**RE: 21st Century Academy
4300 Cutler Ave NE
Grading Plan
Engineer's Stamp Date: 04/10/18
Hydrology File: H17D115**

Based upon the information provided in your submittal received 04/17/18, the Grading and Drainage Plan is **not** approved for Building Permit. The following comments need to be addressed for approval of the above referenced project:

C101

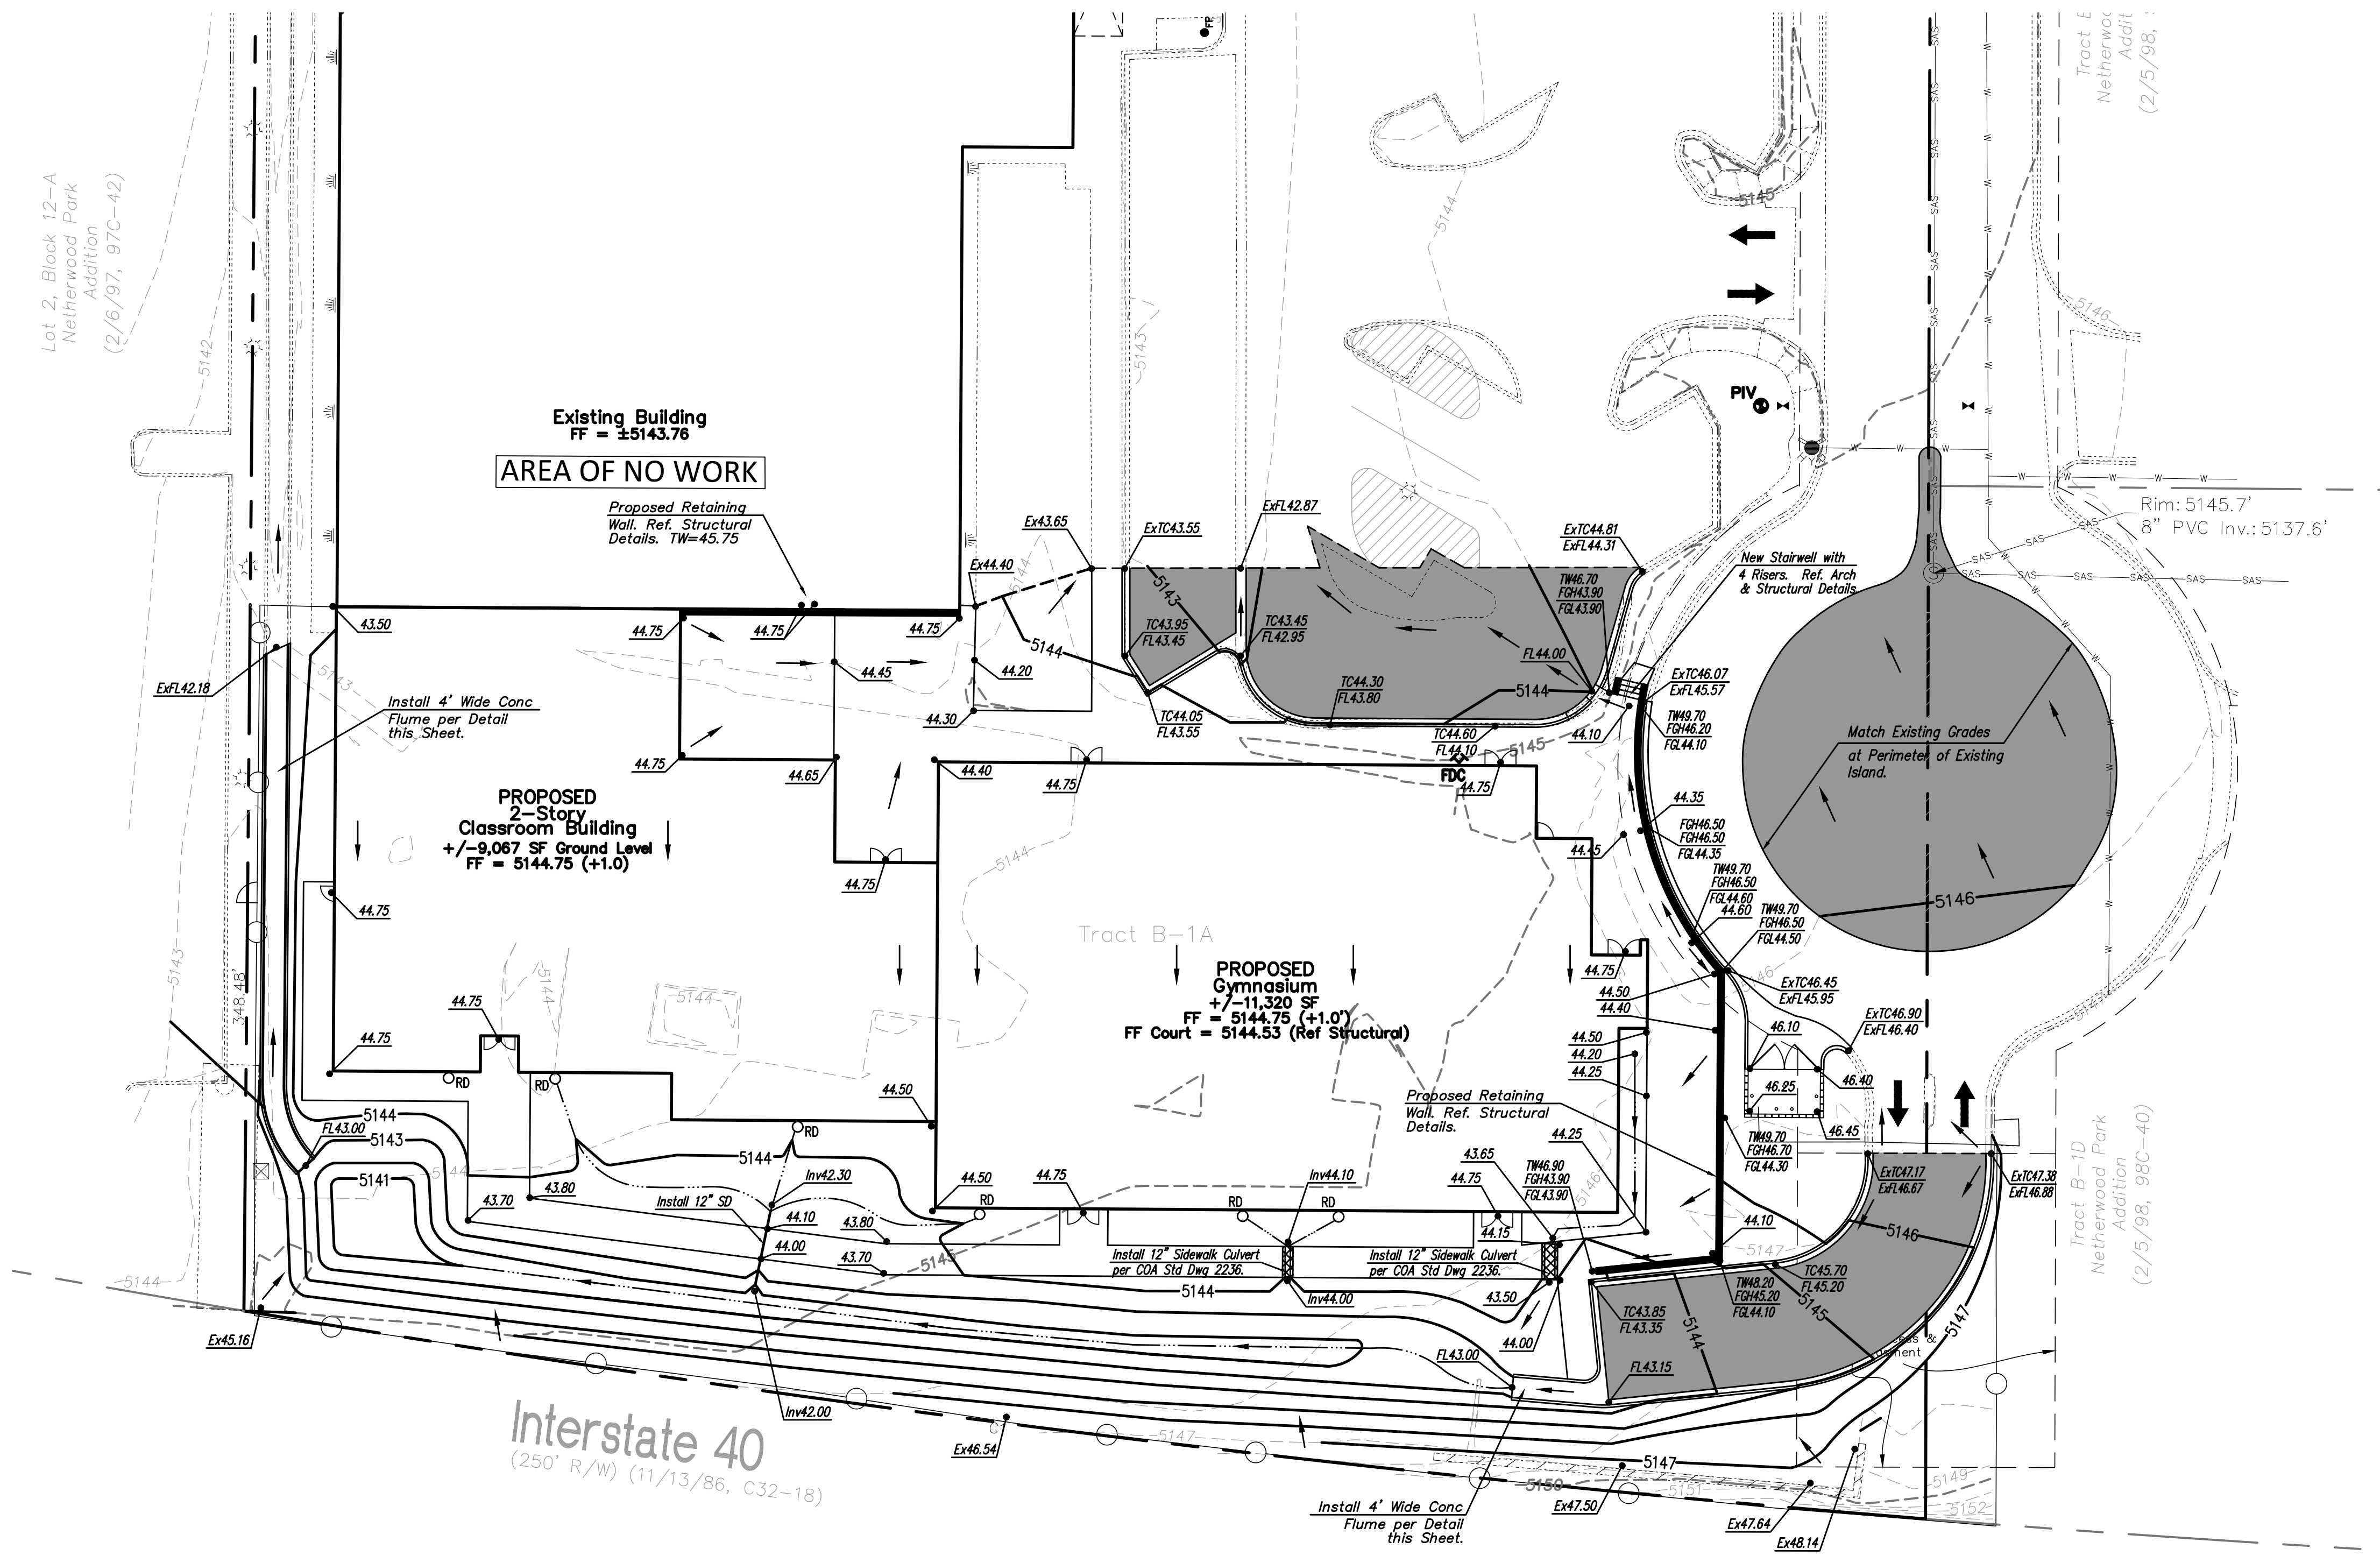
StormTech System shifted northeast 25.5'. Profiles and HGL adjusted. Misc Grades modified per clouded areas. JTW
